Title: Cavalon fuel-tank inlay ring							
SB-109 Iss1	Related documents Modification: MC-347 CCAR No.: None	Compliance Category: OPTIONAL or					
Appli	RECOMMENDED or						
Aircraft type & model: Cavalon	Aircraft serial Nos. affected: RSUK/all prior to CVLN/018	MANDATORY					
The maintenance manual to be referenced is this stated or subsequent issue.		RSUK0288 Iss: 3

Reason and overview of the Service Bulletin (cause of problem if known)

Inlay plate under installation

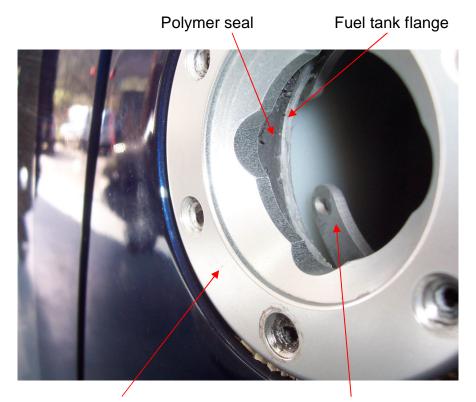
Some Cavalon owners have complained of a fuel smell in the cockpit, noticeable mainly after standing with the doors closed. This has been traced to small gaps in the sealing between the fuel tank flange and the composite body. Under this service bulletin an aluminium "inlay ring" is placed inside the filler neck and by means of longer fuel filler mounting screws allows the fuel tank flange to be pulled uniformly against the seal.

Two rivnut heads slotted for drilling

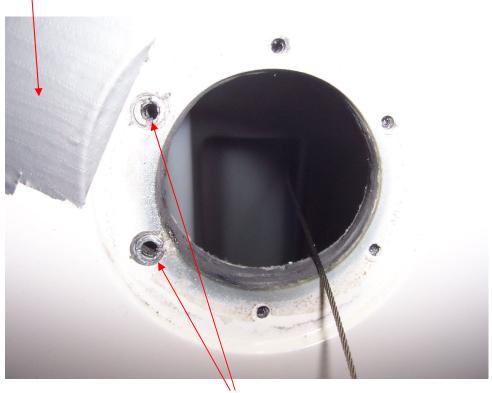
2. The two most fwd screw positions do not pass into the fuel tank void but into rivnuts secured in the body moulding. These must be carefully and progressively drilled-thru 4.1mm diameter. If the drill bites into the rivnut and causes it to spin in the body the fuel cap mounting plate must be removed completely by prising it off the cork gasket between it and the body.(The gasket is bonded in place with Loctite 5331 sealant). The rivnut heads may then be slotted (using a Dremmel or similar tool) to enable the rivnut heads to be held still during drilling.
